# River Medway (Flood Relief) Act 1976

## Inquiry into the Environment Agency's revised Scheme for the Leigh Flood Storage Area, Kent

### Statement of Case

### Appendix 3 – Environment Agency responses to Objections

Figure 1: Key locations of road flooding identified by Penshurst PC

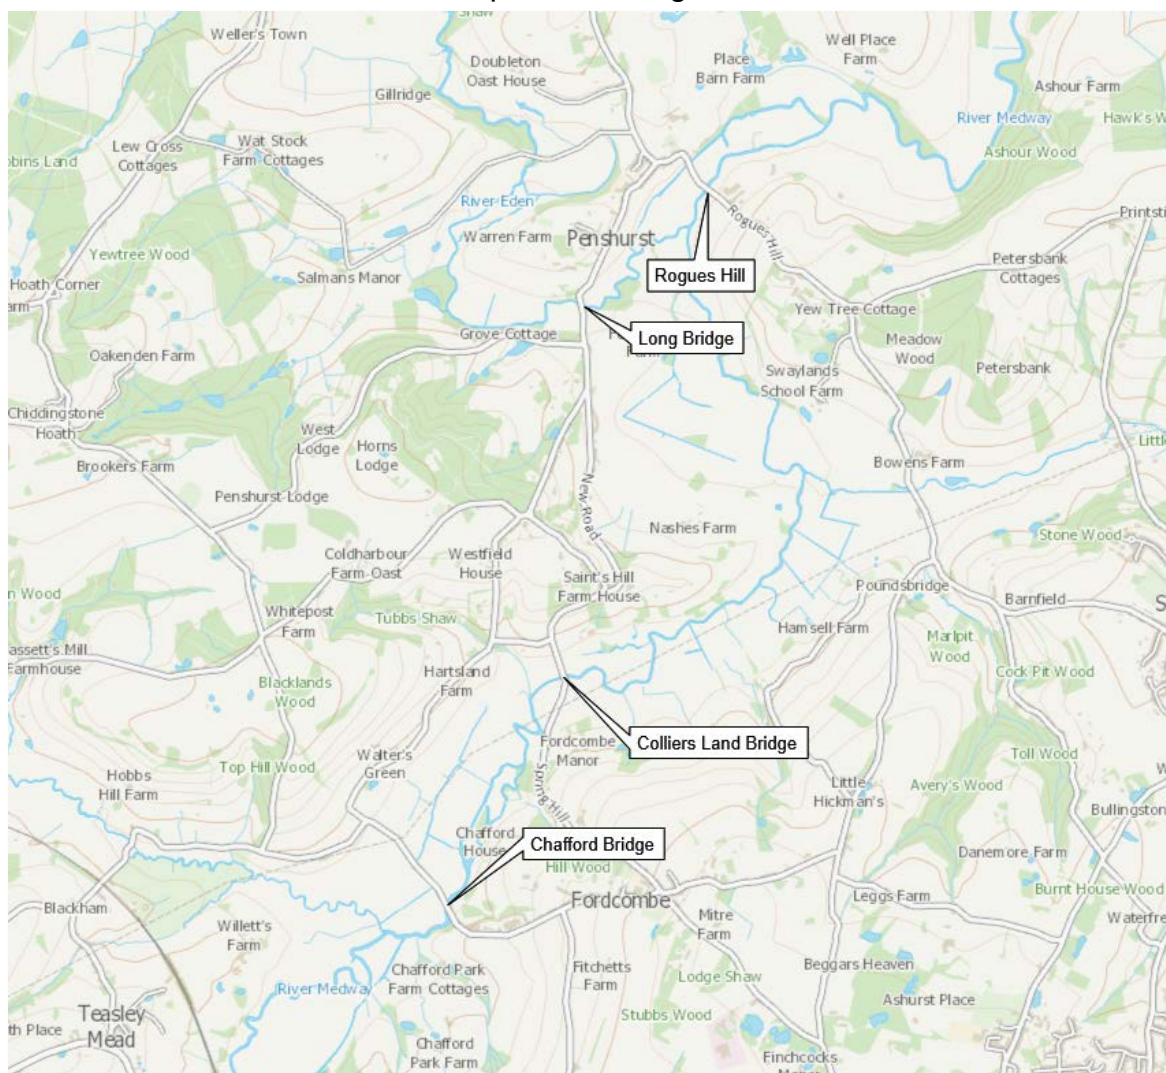
- 1. Key roads around Penshurst, including Chafford Bridge, Colliers Land Bridge, Rogues Hill and Long Bridge currently experience flooding. Penshurst Parish Council is concerned that future use of the Leigh Flood Storage Area (FSA) will exacerbate the situation and cause flooding of the roads on a more regular basis and for a longer period.**

*Roads generally flood and become impassable in the following order: 1) Chafford Bridge, 2) Colliers Land Bridge, 3) Rogues Hill, 4) Long Bridge.*

The locations are shown on the map below in Figure 1.

Figure 1: Increase in flood depth in a 1.33% flood event. 28.05m AOD vs 28.6m AOD

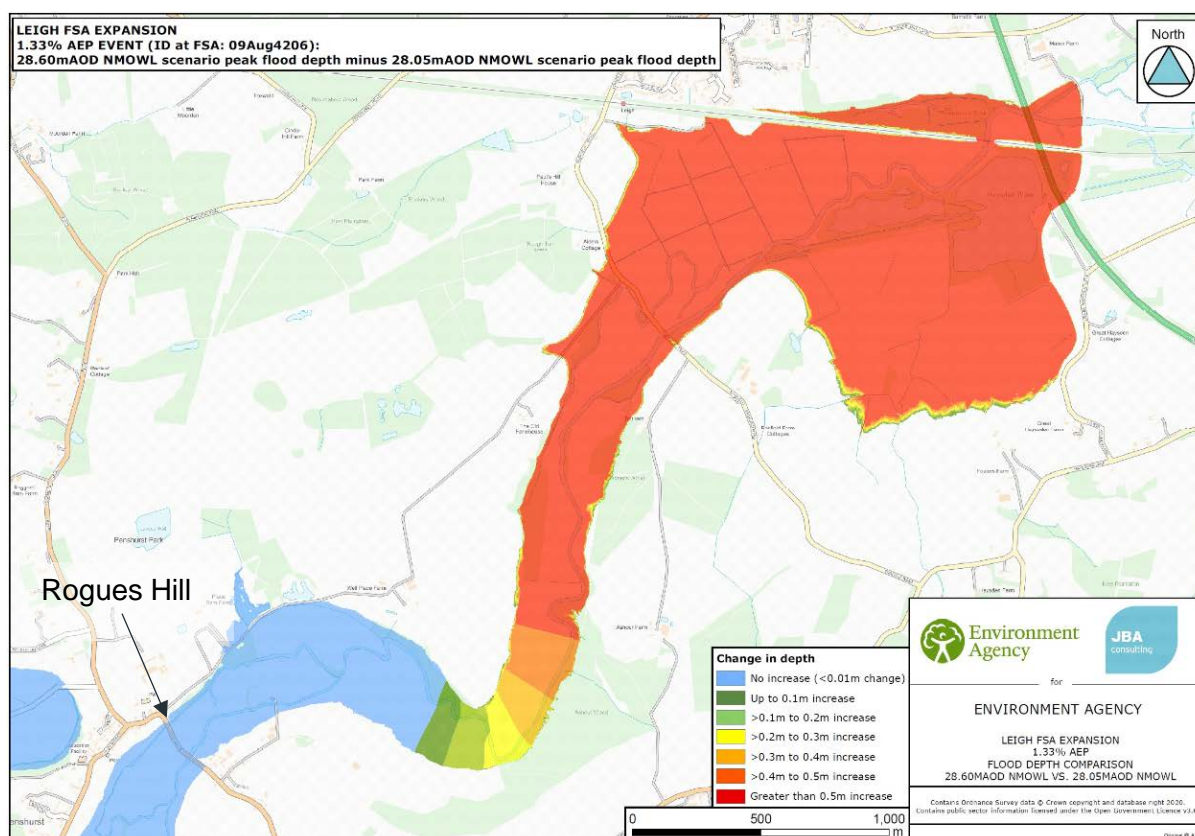
#### **2. You state that "Any decisions on flood mitigation works that are likely to have a significant impact on the land or business of the landowner must be based on robust evidence and with all potential solutions fully explored. In this case it is clear that there are some outstanding questions around the technical analysis that must be resolved before a decision is made."**

Our modelling indicates that the proposed change to increase the maximum impoundment level will not increase the depth of flooding above Rogues Hill. This is demonstrated in Figure 1 below. Figure 1 shows the increase in flooding depth from raising the Leigh FSA maximum impoundment level from 28.05m Above Ordnance Datum (AOD) to 28.6m AOD (measured at the main Leigh FSA embankment) during a 1.33% flood event. The map below has been taken from the Flood Risk Assessment for consistency. This map has been updated since the submission of the Application. Whilst it shows greater depth variation lower in the FSA, the point at which the effect of the expansion dissipates remains the same.

Every flood event is different, depending on a number of factors, including soil saturation and weather patterns. The modelled scenario in Figure 1 was chosen to demonstrate the impact of expanding the FSA because it shows the greatest change in flood depths.

*Figure 1: Flooding of Rogues Hill in 1937*

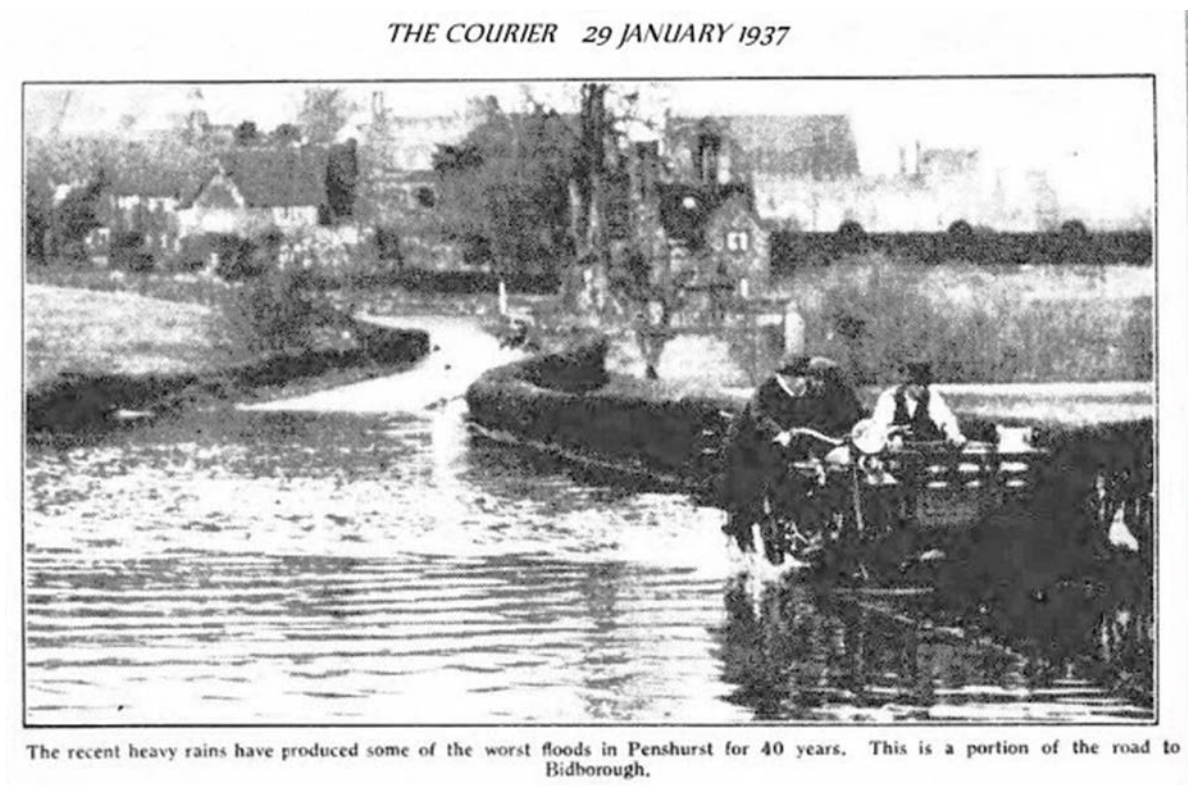
Environment Agency response to your second concern:

There are historical reports of flooding in Penshurst which occurred prior to the construction of the FSA, demonstrating that the area is affected by natural flooding. Indeed, the FSA itself was constructed in response to the 1968 flood when the flooding at Rogues Hill was so severe that the road bridge over the River Medway was damaged and a temporary bridge had to be installed. The photograph below from a newspaper article (Figure 1) shows flooding on Rogues Hill in 1937. These events demonstrate that Rogues Hill was vulnerable to flooding prior to the construction of the FSA.

Figure 6: Increase in flood depth in a 1.33% flood event. 28.05m AOD vs 28.6m AOD

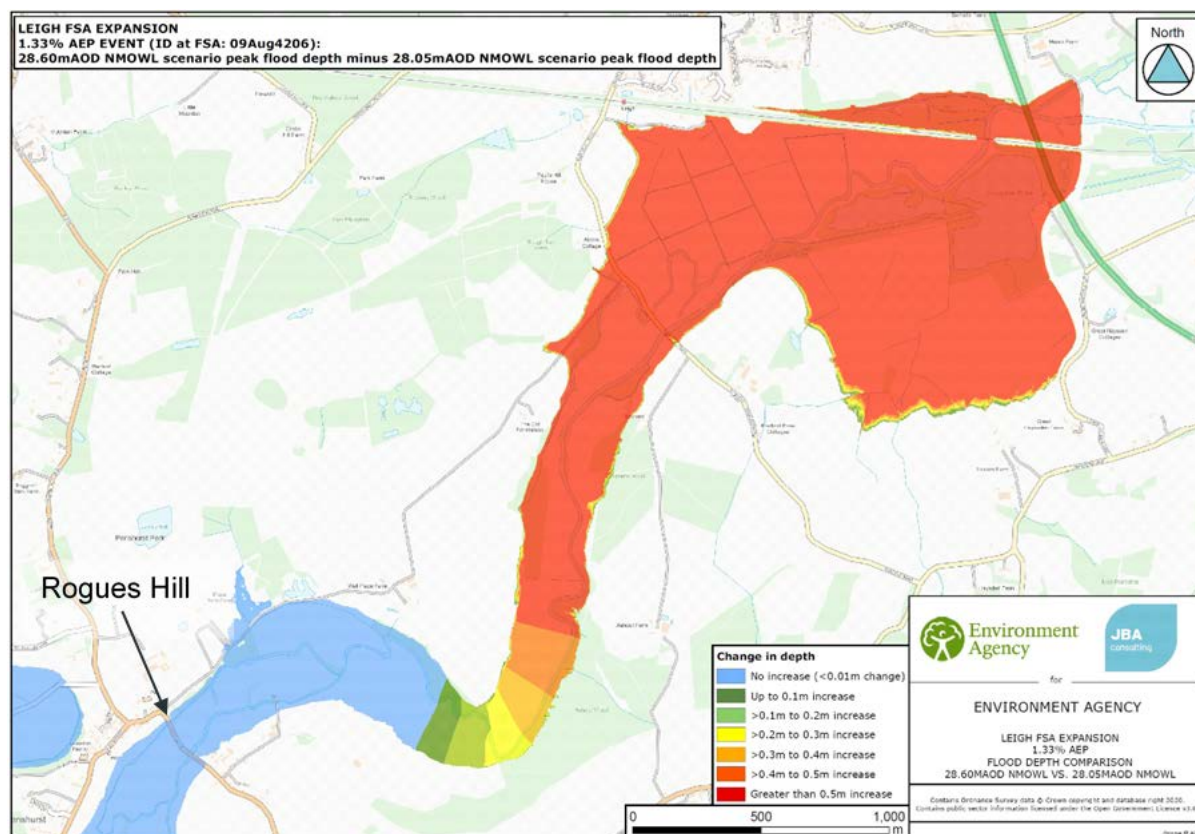
Environment Agency response to your fourth concern:

As explained in Section 4.2 of the Application (pages 24 and 25), whilst the 2015 Medway flood model indicates that in certain circumstances operation of the FSA can add up to 0.1m to the depth of flood water in your garden, the flood model also indicates that the proposal to increase the maximum impoundment level will not further increase the depth of flooding in this location.

This is illustrated in Figure 6 below. Figure 6 shows the increase in flooding depth from raising the Leigh FSA maximum impoundment level from 28.05m AOD to 28.6m AOD (measured at the main Leigh FSA embankment) during a 1.33% flood event. The map below has been taken from the Flood Risk Assessment for consistency. This map has been updated since the submission of the Application. Whilst it shows greater depth variation lower in the FSA, the point at which the effect of the expansion dissipates remains the same.

Every flood event is different, depending on a number of factors, including soil saturation and weather patterns. The modelled scenario in Figure 6 was chosen to demonstrate the impact of expanding the FSA because it shows the greatest change in flood depths.

Figure 1: Increase in flood depth in a 1.33% flood event. 28.05m AOD vs 28.6m AOD

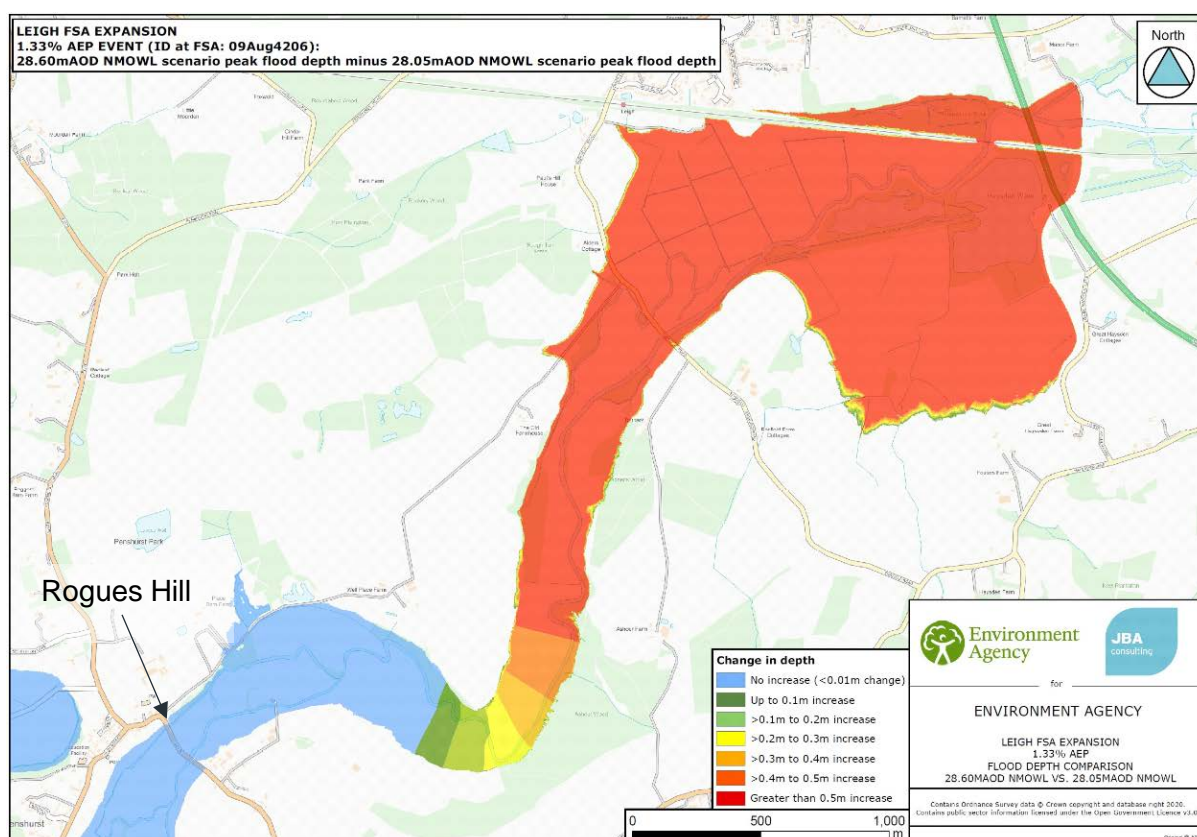
Environment Agency response to point 2.2:

Our modelling indicates that the proposed change to increase the maximum impoundment level will not increase the depth of flooding above Rogues Hill. This is demonstrated in Figure 1 below. Figure 1 shows the increase in flooding depth from raising the Leigh FSA maximum impoundment level from 28.05m Above Ordnance Datum (AOD) to 28.6m AOD (measured at the main Leigh FSA embankment) during a 1.33% flood event. The map below has been taken from the Flood Risk Assessment for consistency. This map has been updated since the submission of the Application. Whilst it shows greater depth variation lower in the FSA, the point at which the effect of the expansion dissipates remains the same.

Every flood event is different, depending on a number of factors, including soil saturation and weather patterns. The modelled scenario in Figure 1 was chosen to demonstrate the impact of expanding the FSA because it shows the greatest change in flood depths.

*Figure 6: Flooding of Rogues Hill in 1937*

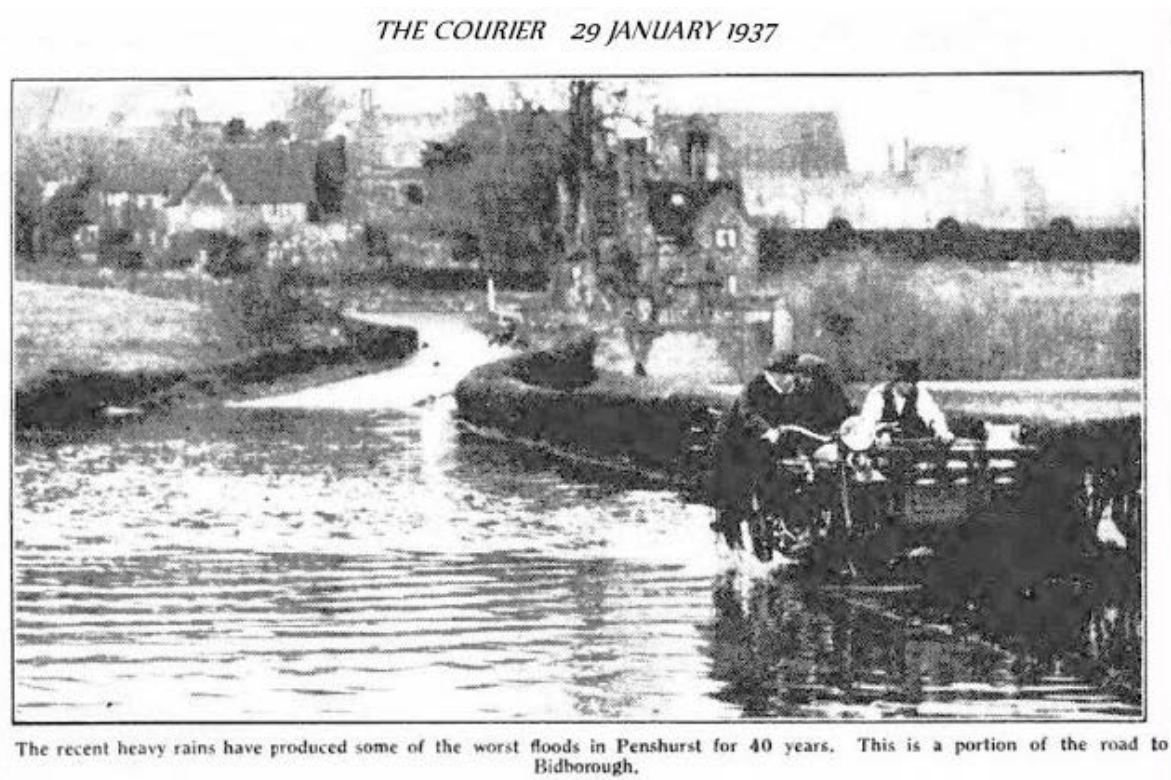
In your representation you suggest that Rogues Hill floods to up to 1m deep as a result of the operation of the FSA. Whilst in certain circumstances the FSA can, when operating, add up to 0.1m to the depth of water at Rogues Hill, the depth and timing of the flooding of Rogues Hill is dictated by upstream flows.

The photograph below from a 1937 newspaper article (Figure 6) shows flooding on Rogues Hill. In 1968 the flooding at this location was so severe that the Rogues Hill road bridge over the River Medway was damaged to such an extent a temporary bridge had to be installed. These events show that Rogues Hill has historically experienced flooding and that it is not the operation of the Leigh FSA that causes flooding.

Figure 1: Increase in flood depth in a 1.33% flood event. 28.05m AOD vs 28.6m AOD

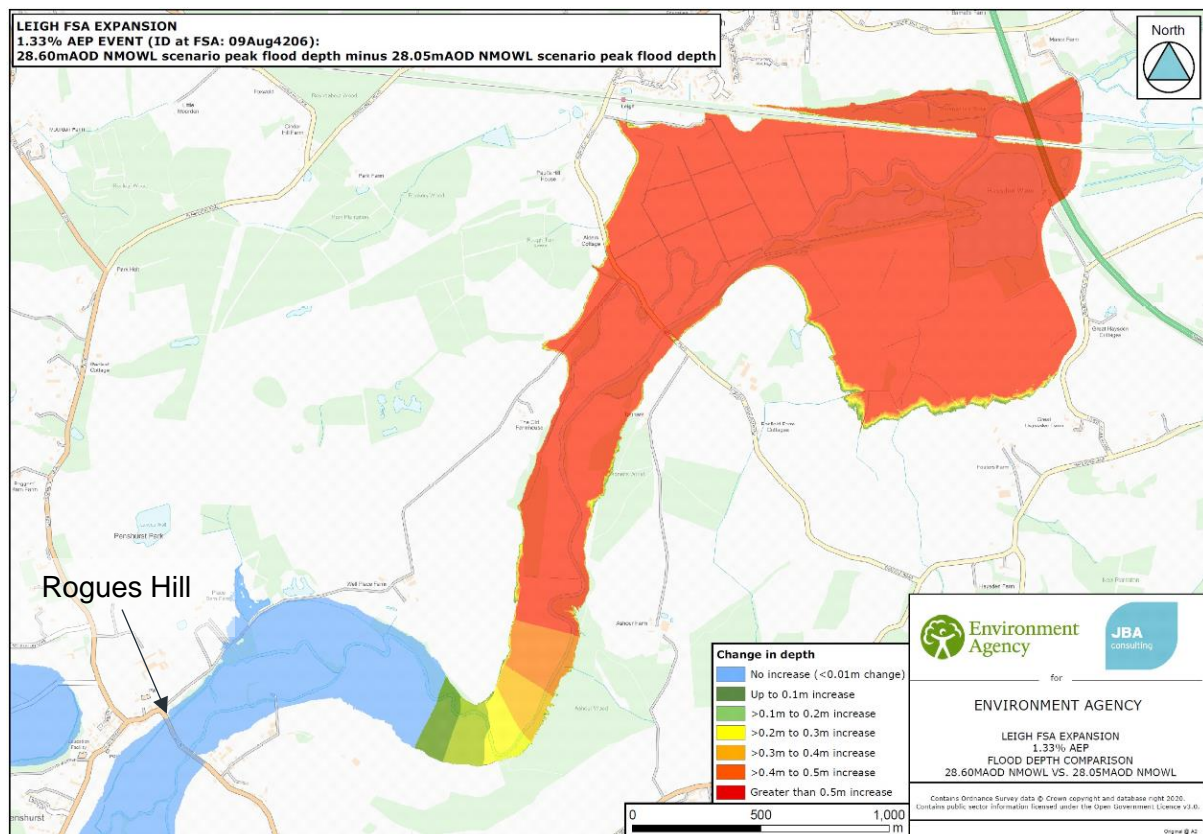
Environment Agency response to point 2.2:

Our modelling indicates that the proposed change to increase the maximum impoundment level will not increase the depth of flooding above Rogues Hill. This is demonstrated in Figure 1 below. Figure 1 shows the increase in flooding depth from raising the Leigh FSA maximum impoundment level from 28.05m Above Ordnance Datum (AOD) to 28.6m AOD (measured at the main Leigh FSA embankment) during a 1.33% flood event. The map below has been taken from the Flood Risk Assessment for consistency. This map has been updated since the submission of the Application. Whilst it shows greater depth variation lower in the FSA, the point at which the effect of the expansion dissipates remains the same.

Every flood event is different, depending on a number of factors, including soil saturation and weather patterns. The modelled scenario in Figure 1 was chosen to demonstrate the impact of expanding the FSA because it shows the greatest change in flood depths.

*Figure 6: Flooding of Rogues Hill in 1937*

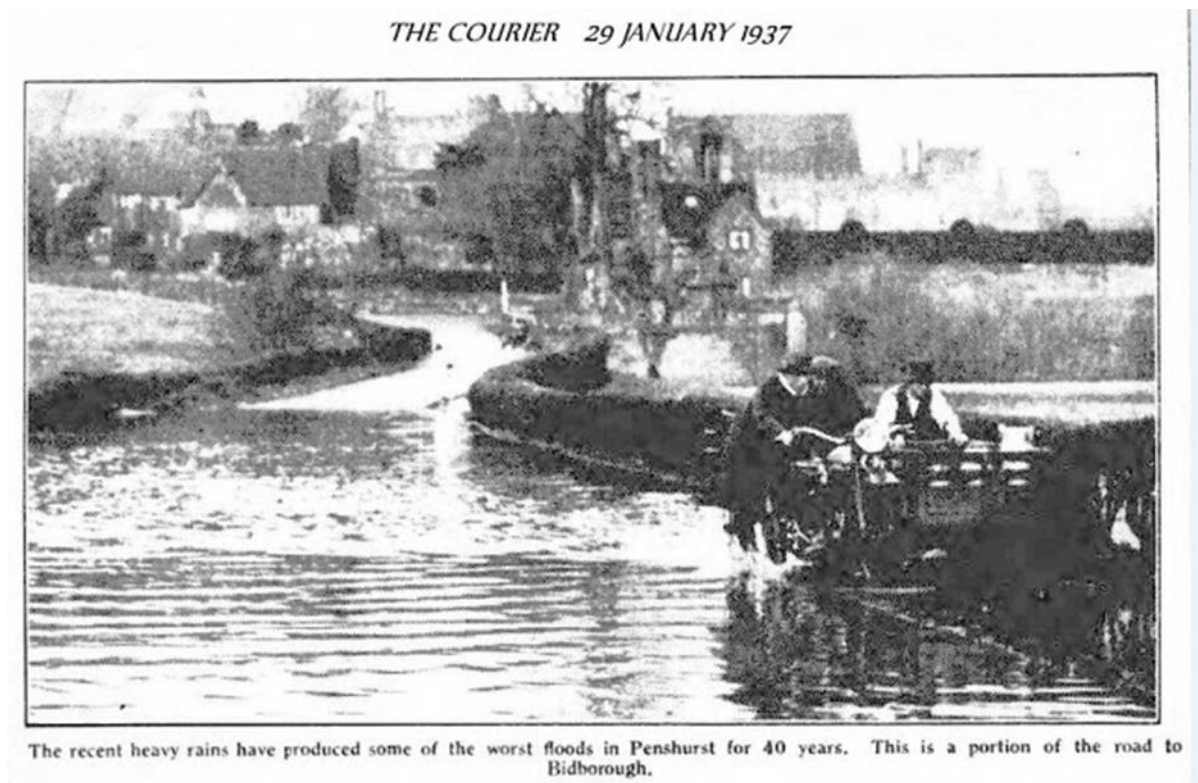
In your representation you suggest that Rogues Hill floods to up to 1m deep as a result of the operation of the FSA. Whilst in certain circumstances the FSA can, when operating, add up to 0.1m to the depth of water at Rogues Hill, the depth and timing of the flooding of Rogues Hill is dictated by upstream flows.

The photograph below from a 1937 newspaper article (Figure 6) shows flooding on Rogues Hill. In 1968 the flooding at this location was so severe that the Rogues Hill road bridge over the River Medway was damaged to such an extent a temporary bridge had to be installed. These events show that Rogues Hill has historically experienced flooding and that it is not the operation of the Leigh FSA that causes flooding.
